## AMENDMENTS TO THE DRAWINGS

Appln. No. 09/552,590  
Amend. Dated: 3/18/04  
Reply to Office Action of 12/19/03  
Replacement Sheet

FIG. 1

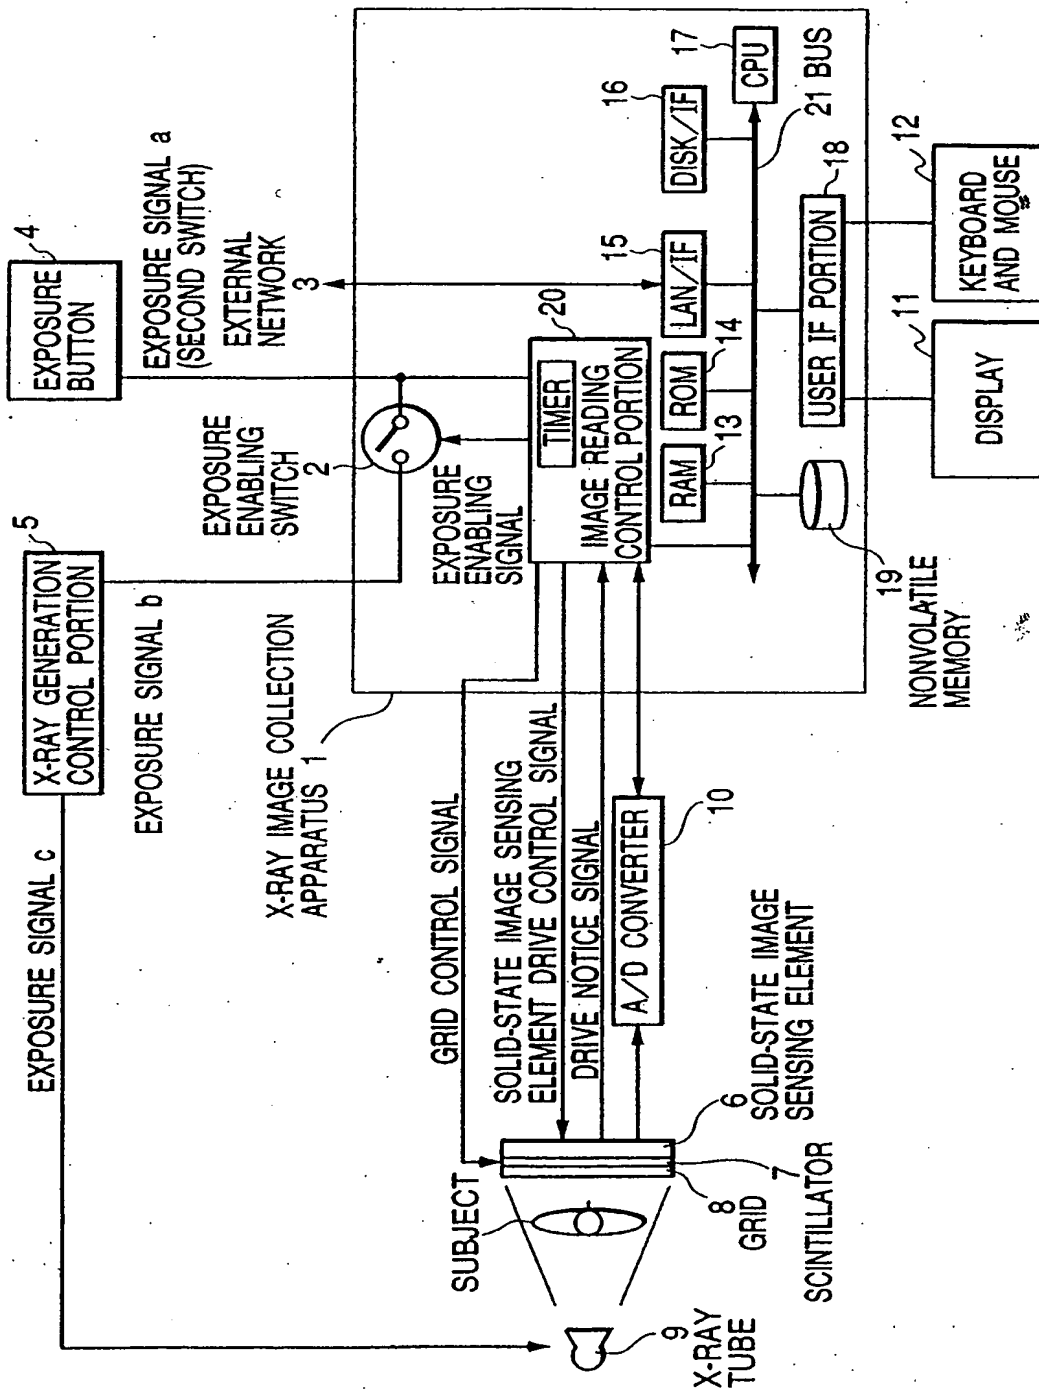
Fig. 1, change "X-RAY GENERATOR CONTROL PORTION" to --X-RAY GENERATION CONTROL PORTION--, change "IMAGE READ CONTROL UNIT" to --IMAGE READING CONTROL PORTION--, change "EXPOSURE ENABLING SWITCH 10" to --EXPOSURE ENABLING SWITCH 2--, and delete "EXTERNAL PORTABLE STORAGE MEDIUM 2".

**FIG. 2**

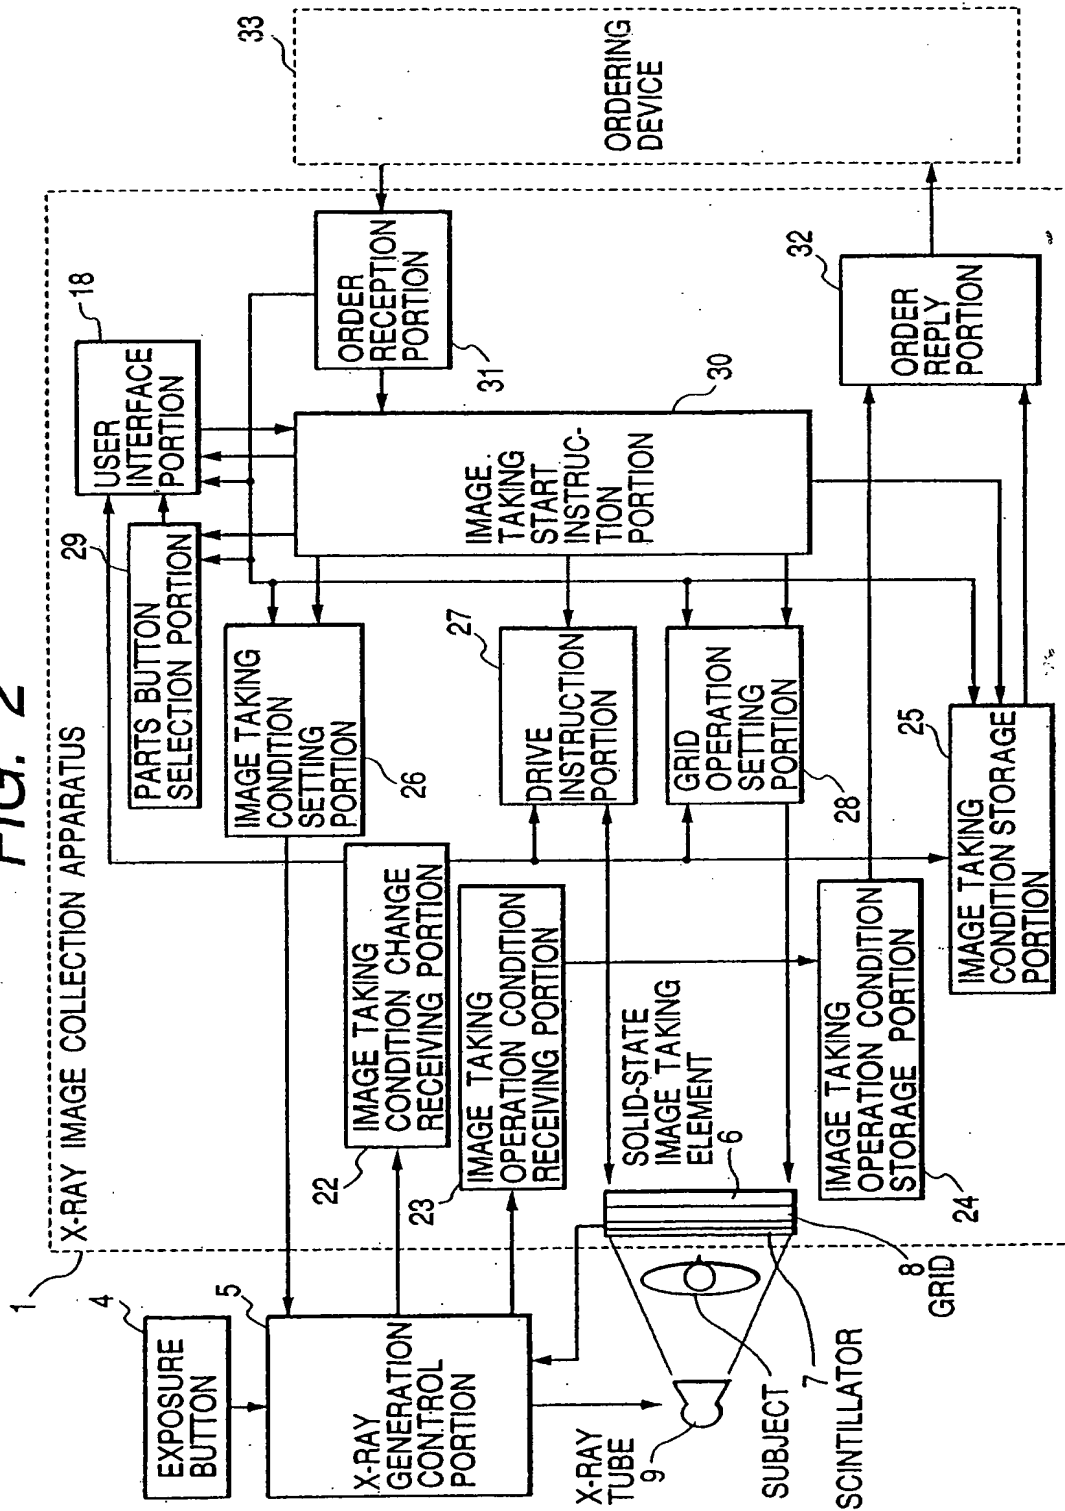
Fig. 2, change "X-RAY GENERATOR" to --X-RAY GENERATION CONTROL PORTION--, change "IMAGE SENSING CONDITION CHANGE RECEIVING PORTION" to --IMAGE TAKING CONDITION CHANGE RECEIVING PORTION--, change "IMAGE SENSING OPERATION CONDITION RECEIVING PORTION" to --IMAGE TAKING OPERATION CONDITION RECEIVING PORTION--, change "SOLID-STATE IMAGE SENSING ELEMENT" to --SOLID-STATE IMAGE TAKING ELEMENT--, change "IMAGE SENSING OPERATION CONDITION STORING PORTION" to --IMAGE TAKING OPERATION CONDITION STORAGE PORTION--, change "IMAGE SENSING CONDITION STORING PORTION" to --IMAGE TAKING CONDITION STORAGE PORTION--, change "IMAGE SENSING CONDITION SETTING PORTION" to --IMAGE TAKING CONDITION

SETTING PORTION--, change "IMAGE SENSING START INSTRUCTION PORTION" to --IMAGE TAKING START INSTRUCTION PORTION--, change "ORDER RECEIVING PORTION" to --ORDER RECEPTION PORTION--, and delete "21 PHOTO TIMER".

FIG. 3

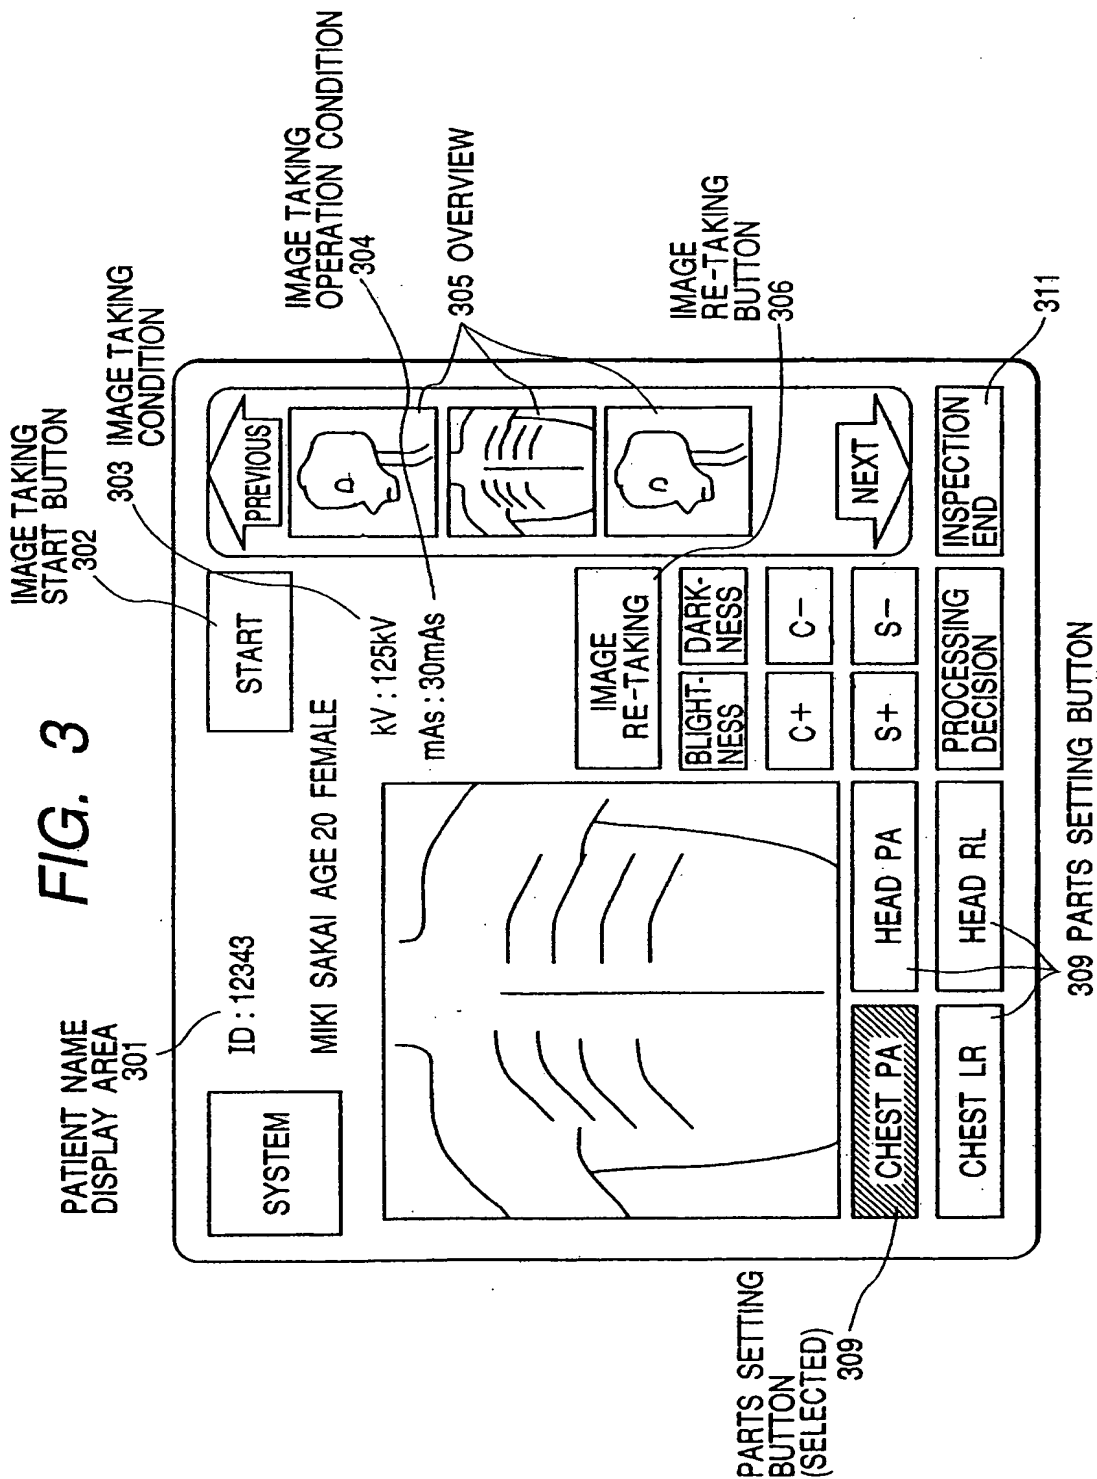
Fig. 3, change "PARTS SETTING BUTTON (SELECTED) 310" to --PARTS SETTING BUTTON (SELECTED) 309--, change "IMAGE SENSING START BUTTON 302" to --IMAGE TAKING START BUTTON 302--, change "303 IMAGE SENSING CONDITION" to --303 IMAGE TAKING CONDITION--, change "IMAGE SENSING OPERATION CONDITION 304" to --IMAGE TAKING OPERATION CONDITION 304-- and delete the leader line between 304 and kV: 125kV, change "RE-IMAGE SENSING" to --IMAGE RE-TAKING--, change "305 OVER VIEW" to --305 OVERVIEW--, change RE-IMAGE SENSING BUTTON 306" to --IMAGE RE-TAKING BUTTON 306--, delete "307 IMAGE PROCESSING CHANGE INSTRUCTION BUTTON etc." and corresponding leader lines, delete "308", and add leader line between "309 PARTS SETTING BUTTON" and "HEAD RL".
